# Access Compliance Report

## Public Rights-of-Way

### (Curb Ramps)

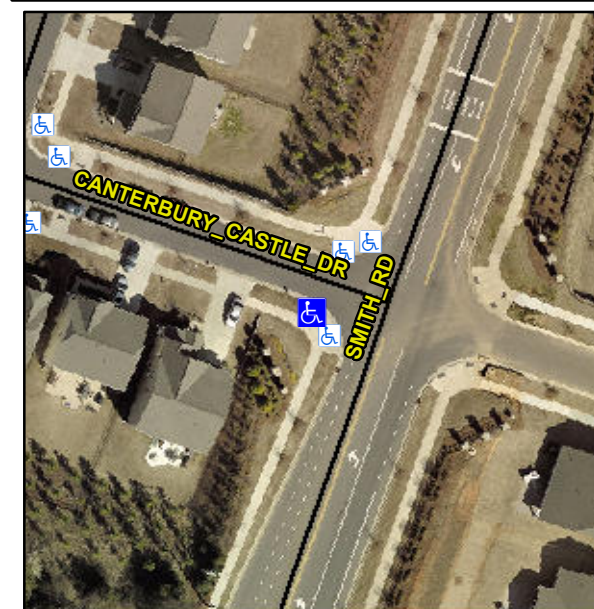
Intersection ID: N/A	Main Street: SMITH_RD	Cross Street: CANTERBURY_CASTLE_DR	Location: SW
ADA ID: BBDA30B8639A	Ramp Type: Perp	Initial Pass/Fail: Fail	Overall Compliance: No
Severity Score: 37.5			
Codes/Mitigation Info/Possible Solution		Field Measurements/Component Compliance

**Not Found, R304.2.2, R304.5.3**

**Remove & Replace Entire Ramp.**
